BOTTOM PLATE MODIFICATION SK. 1

CALIPER MOUNTING SK.2

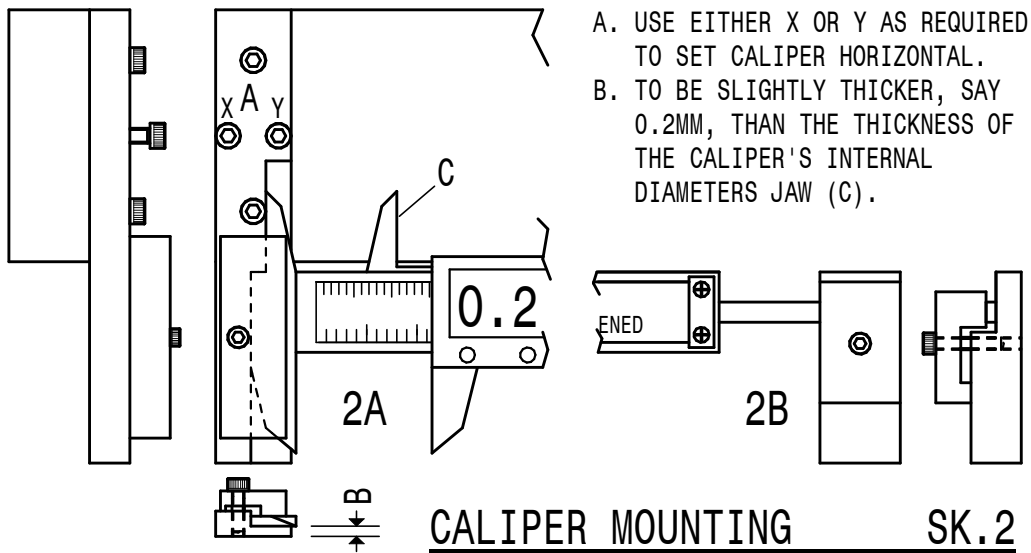
MAKING THE BOTTOM PLATE (C17) THICKER AND WITH A RECESS WILL ENABLE THE CROSS SLIDE TO BE MOVED NEARER THE HEAD'S COLUMNS
